SAFETY ALERT

Subject: TPP SW-3 Navaid information missing for Missed Approach Procedure instructions
on ILS Z RWY 16R, ORIG, for Van Nuys (VNY), Van Nuys, CA

ILS Z RWY 16R
VAN NUYS (VNY)

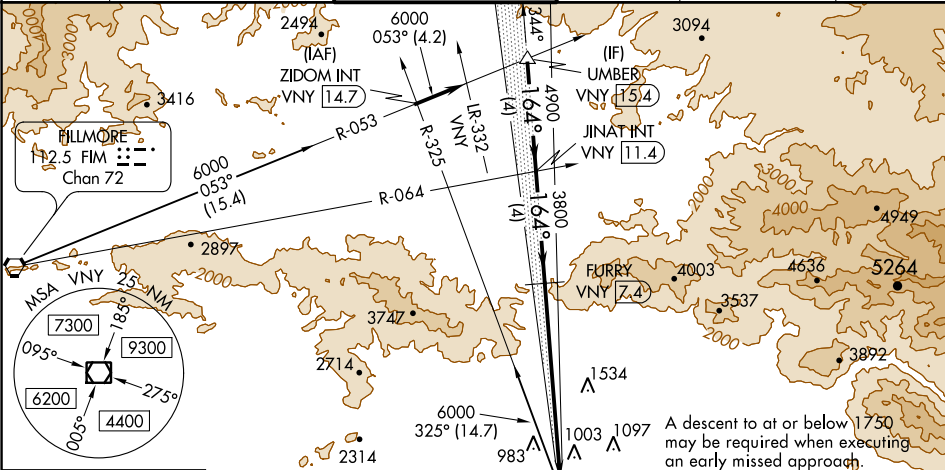
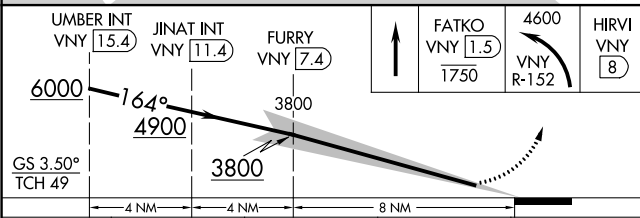
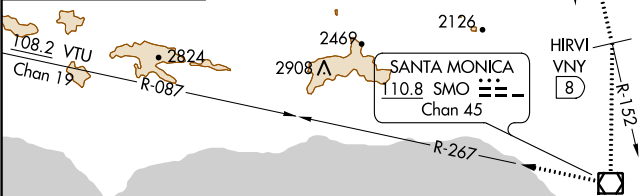
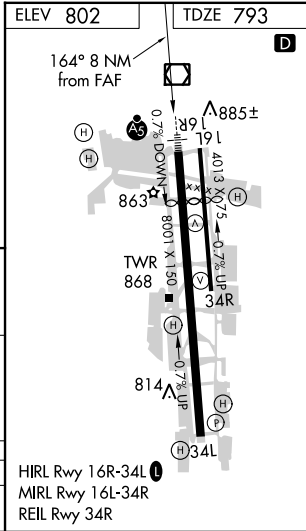
In the Terminal Procedure Publication, SW-3 volume, and the digital-Terminal Procedures Publication, effective July 21, 2016, for Van Nuys (VNY), Van Nuys, CA, ILS Z RWY 16R, ORIG, there is a missing Navaid, and its related data to be used for Missed Approach Procedure instructions. The corrected chart will be published on Sep 15, 2016.

Attached is the correct file for the SW-3 volume ILS Z RWY 16R, ORIG, for Van Nuys (VNY), Van Nuys, CA.

MISSED APPROACH: Climb to cross FATKO/VNY VOR/DME 1.5 DME at or below 1750 then climbing left turn to 4600 on VNY VOR/DME R-152 direct HIRVI/VNY VOR/DME 8 DME then direct SMO VOR/DME and on SMO VOR/DME R-267 and on VTU VOR/DME R-087 to VTU VOR/DME and hold.
